BUILDING CODE OF AUSTRALIA COMPLIANCE ASSESSMENT REPORT

MAIN WORKS FOR WATERLOO MIXED USE DEVELOPMENT (HDA) – SSD-80441462

881-885 BOURKE STREET, WATERLOO

REPORT NO. ► 13143.9 – Parcel 4 – Rev.00

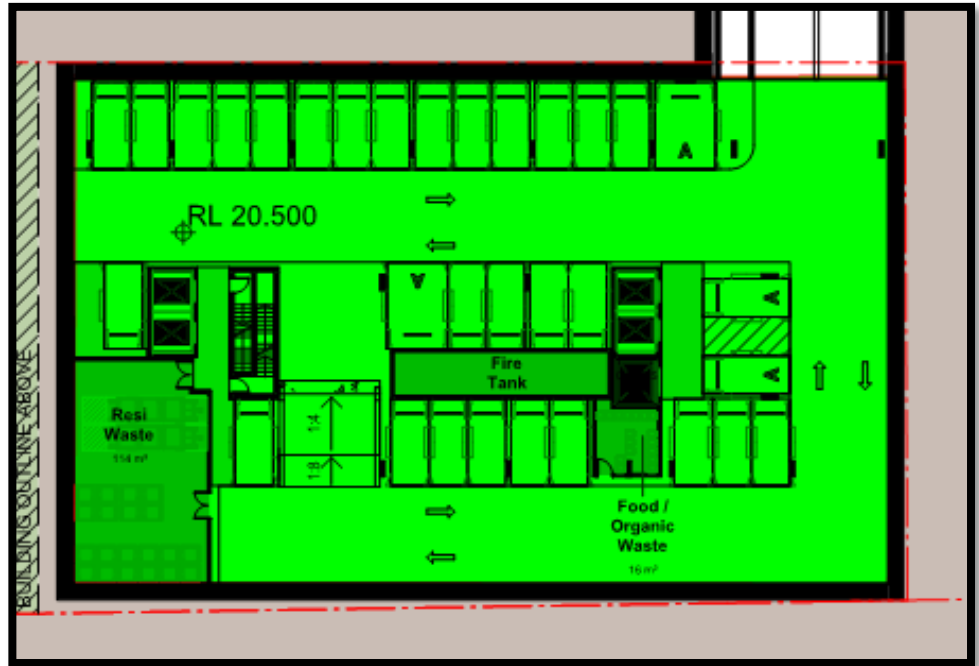
External walls are required to maintain an FRL in accordance with Specification 5. The Eastern Boundary Walkway is considered a side boundary and as such, the fire source feature. This wall requires the following FRL's:

As a result of the above, these walls on both Parcels 1 and 4 have likely not been considered as requiring an FRL, however, technically these do under DTS due to a side

Basement 2

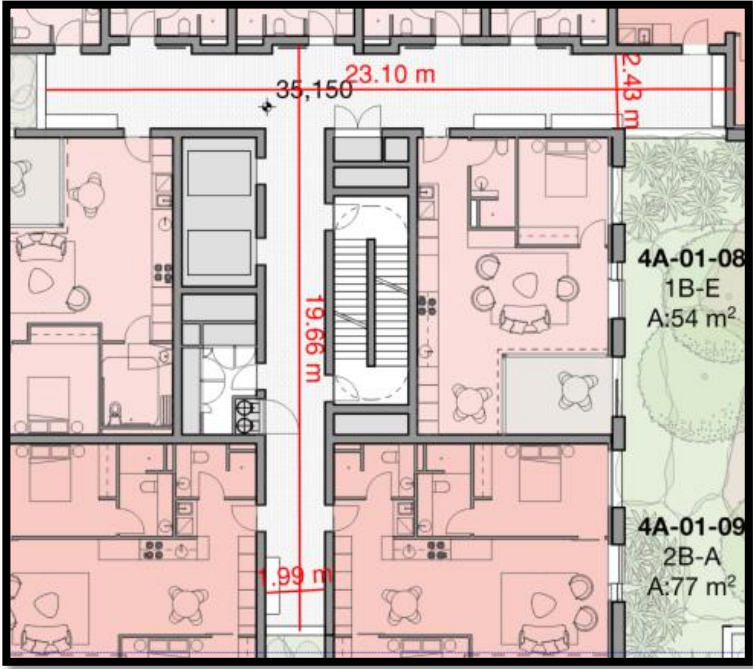
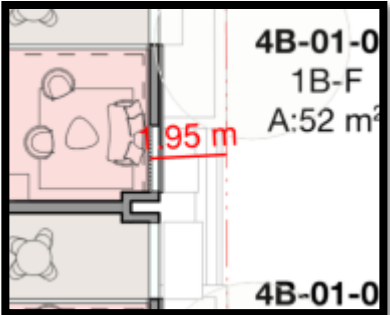
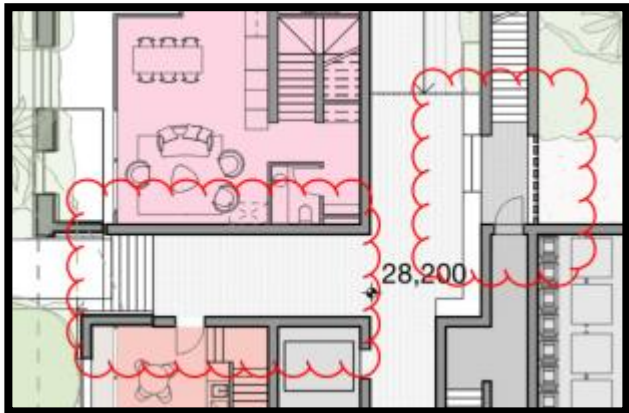
BCA Clause	Deemed-to-Satisfy Provision to be addressed										
	boundary passing through the lot. It is recommended this be considered in the Fire Engineering Strategy and easements or a right of way be applied to these boundaries to ensure there is no future buildings placed on these portions of the land. Further Information Required – Slab Set-downs and Cavities - Any cavities provided within the external wall compromising horizontal and vertical fire separation and not fire stopped with a tested system is to be addressed by way of a Performance Solution by the fire engineer at CC stage. Junction details to be provided at CC stage. - The fire engineer is to address by way of a Performance Solution at CC stage set-downs proposed within internal wet areas reducing the thickness of the slab and FRL achieved by the slab.										
C2D10 Non-Combustible Elements	Further Information Required – External Wall Test Reports External Walls on a structure of Type A Construction (applicable to this building) are required to be non-combustible when tested in accordance with AS1530.1. No specifications or testing reports have been provided for the external walls of this building at this stage, and as such further information is required to determine compliance. It is recommended that this documentation be supplied to AED and the Principal Certifier to determine compliance with C2D10 at the Construction Certificate stage.										
C3D8 Fire Walls	DTS Departure – Separation by Fire Walls Different buildings are required to be separated by fire walls in accordance with this part. Currently, all buildings are connected as a United Building. This means it should be assessed as a single building as opposed to multiple buildings.  AED recommend separation by fire walls and fire doors to ensure the buildings can be considered separate. Alternatively, new plans are to be assessed with the combined as fire source features and travel distances will drastically change.										
C3D9 Separation of Classifications in the Same Storey	Compliance Required – Separation of Classifications Each classification is required to be separated within each storey by construction comply with that in Tables SC11a-SC11g of Specification 5. Should compliance not be achieved through a DTS compliant amendment to the plans, then a Performance-Based Fire Engineered Solution is required to be obtained. The following assessment of each main area is established based on the overall areas of each classification.

Ground Floor

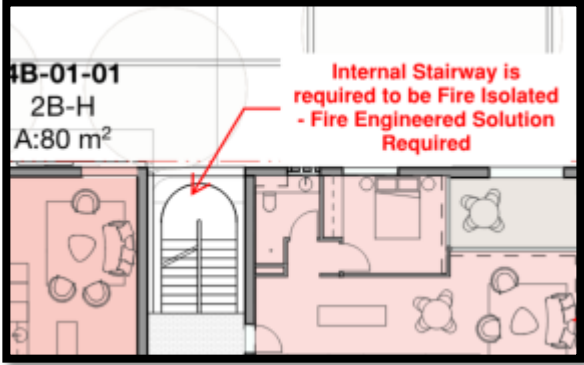
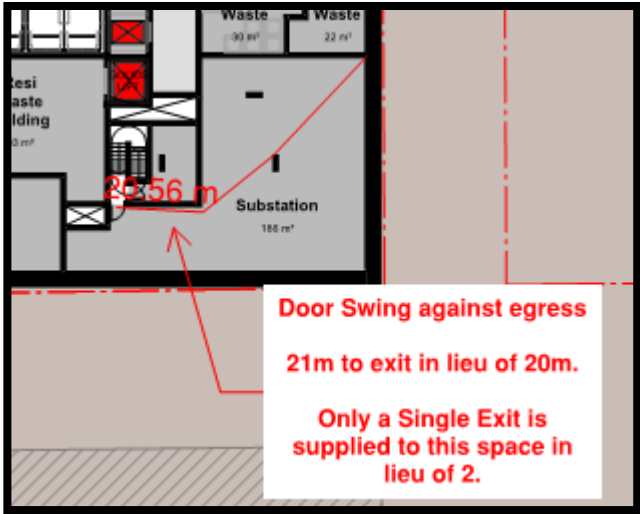
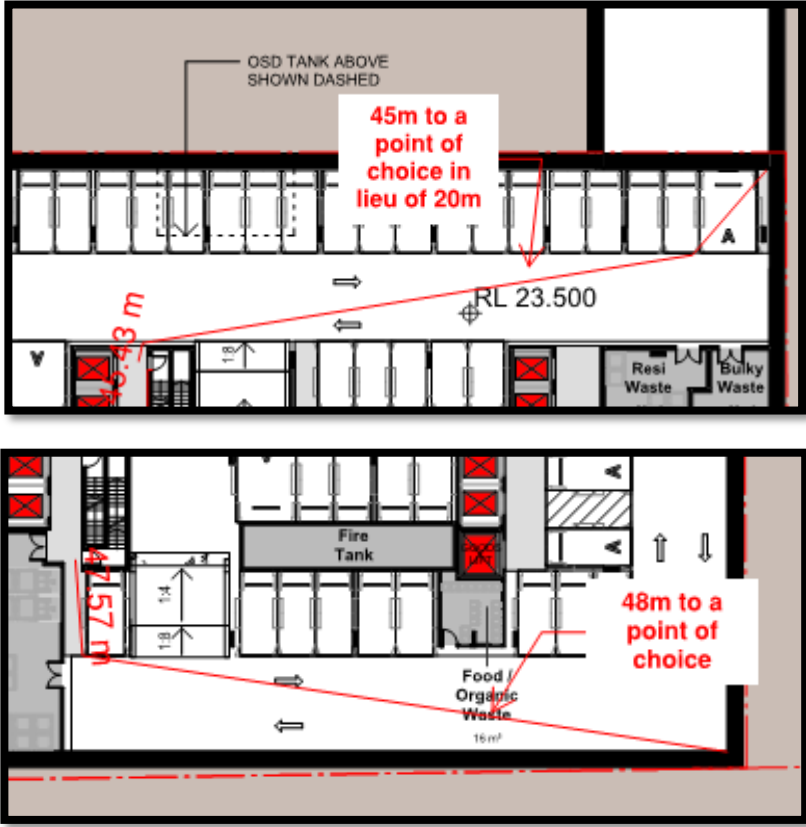
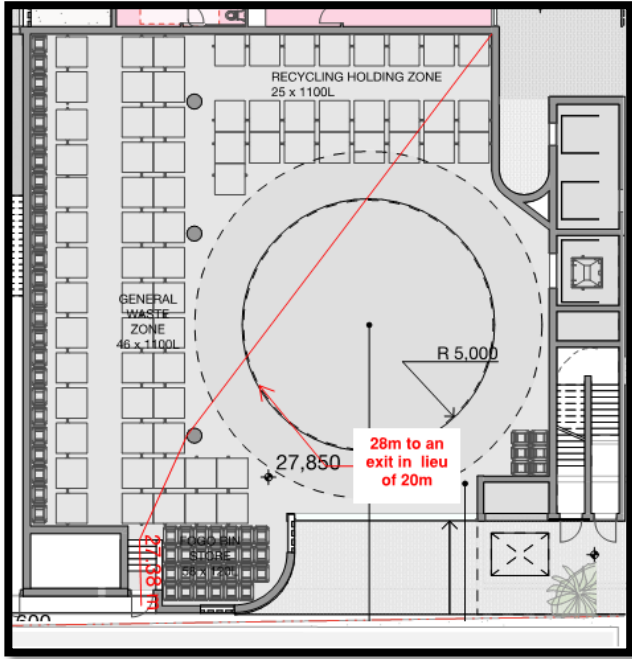
BCA Clause	Deemed-to-Satisfy Provision to be addressed
	obtained. This is also a DTS departure for the external wall FRL being required to be maintained. AED recommend that a performance solution is obtained from a suitable qualified fire engineer to rationalise the FRL's of the storage and retail areas. It is noted that there are limited fire stopping products available for services penetrating floors that require a 180/180/180 and 240/240/240 FRL.
C3D15 Public Corridors in Class 2 and 3 Buildings	DTS Departure – Corridor Length Corridors in Class 2/3 portion of the building are not permitted to exceed 40m, unless they are smoke separated to not exceed 40m. Currently, the corridors in the worst case are 48m in total length (typical issue through all residential corridors shown).  As such, this is required to be addressed through a fire engineered solution, or alternatively, have it smoke separated to not exceed 40m.

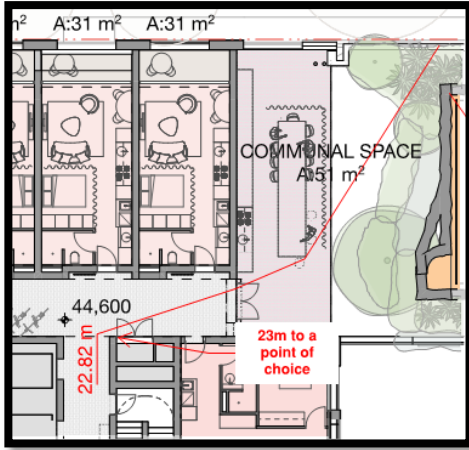
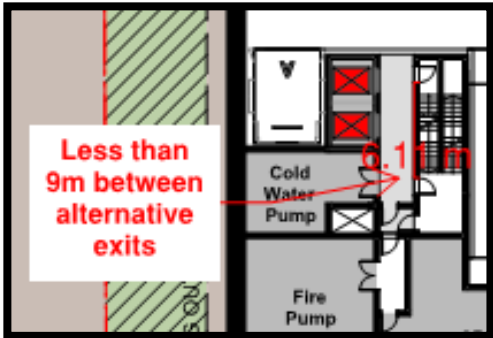
C4D3 Protection of Openings in External Walls	DTS Departure / Further Information Required – Boundary Setbacks Openings within 3m of a boundary are required to be separated in accordance with C4D5. <u>The north, east and south boundaries may become fire source features depending on if these are registered roads.</u> An example is the following:  As a result, many openings along these boundaries may require protection. Confirmation is required to be supplied to detail the locations of lot boundaries through the provision of a Deposited Plan to be supplied on application for a Construction Certificate. Alternatively, the DA will stipulate any lot subdivision or consolidation. Once this has been confirmed, the extent of the FER will be required to be addressed.
C4D4	Further Information Required – Openings in Different Fire Compartments

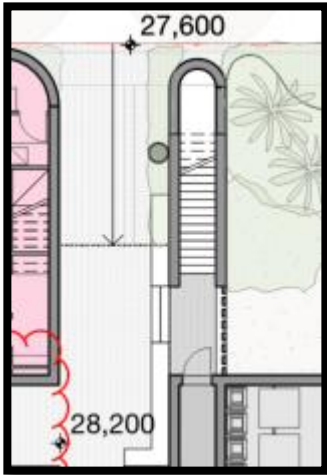
Further specifications are required to be supplied to confirm compliance.	Location	FRL (in minutes): <i>Structural adequacy / Integrity / Insulation</i>				Class 2, 3 or 4 part	Class 5, 7a or 9	Class 6	Class 7b or 8	Fire-resisting lift and stair shafts	-/90/90	-/120/120	-120/120	-/120/120	Bounding public corridors, public lobbies and the like	-/60/60	-/-/-	-/-/-	-/-/-	Between or bounding sole-occupancy units	-/60/60	-/-/-	-/-/-	-/-/-	Ventilating, pipe, garbage, and like shafts not used for the discharge of hot products of combustion	-/90/90	-/90/90	-/120/120	-/120/120
Location	FRL (in minutes): <i>Structural adequacy / Integrity / Insulation</i>																													
	Class 2, 3 or 4 part	Class 5, 7a or 9	Class 6	Class 7b or 8																										
Fire-resisting lift and stair shafts	-/90/90	-/120/120	-120/120	-/120/120																										
Bounding public corridors, public lobbies and the like	-/60/60	-/-/-	-/-/-	-/-/-																										
Between or bounding sole-occupancy units	-/60/60	-/-/-	-/-/-	-/-/-																										
Ventilating, pipe, garbage, and like shafts not used for the discharge of hot products of combustion	-/90/90	-/90/90	-/120/120	-/120/120																										
C4D14 Openings for Shafts	Further Information Required – Shaft Construction or Penetrations Sealed in accordance with AS1530.4 Confirmation is required to be supplied to confirm the construction methods for what appears to be shafts and the openings applicable at doorways for those shafts:

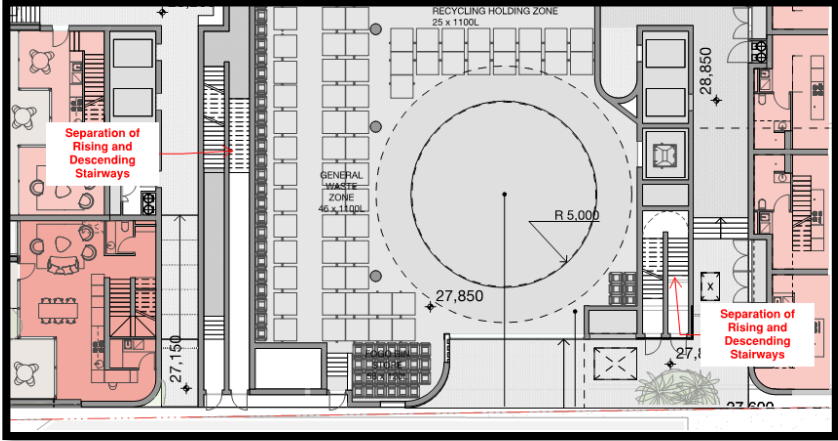
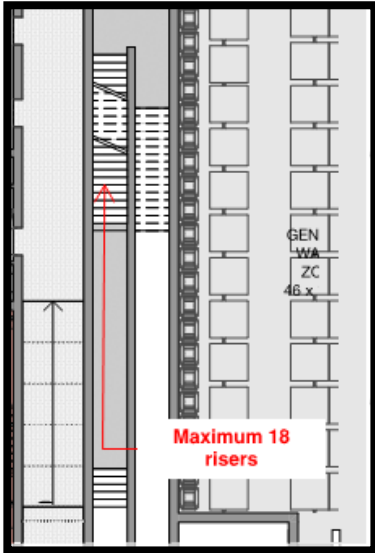
BCA Clause	Deemed-to-Satisfy Provision to be addressed
	 Full specifications and testing reports are required to be supplied to detail the shaft construction for the garbage chutes, hydraulic shafts, mechanical shafts, and electrical shafts as applicable. In addition, this is required to be supplied for the construction of any doorways for service cupboards, or confirmation if they are being sealed at the floors and walls in accordance with a tested system to AS1530.4.
D2D3 Number of Exits Required	DTS Departure – Number of Exits Multiple portions of the building are not showing doors. For example, the ground floor (see the following):  DTS Departure – Less than 2 Exits to Parts of the Building Under D2D3 (7), all parts of the building require access to at least 2 exits. Currently, there are parts of the building that provide access to only one exit:

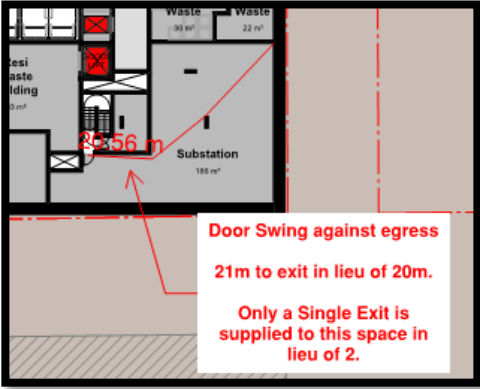
BCA Clause	Deemed-to-Satisfy Provision to be addressed
	 As such, this should either be addressed through a re-design, or a fire engineered solution.
D2D4 When fire-isolated stairways and ramps are required	DTS Departure – Non-fire Isolated Stairway Stairways connecting more than 2 storeys are required to be fire isolated. The internal stairway connecting the Class 2 portions of the building is proposed not to be fire isolated – as such not complying with this clause:
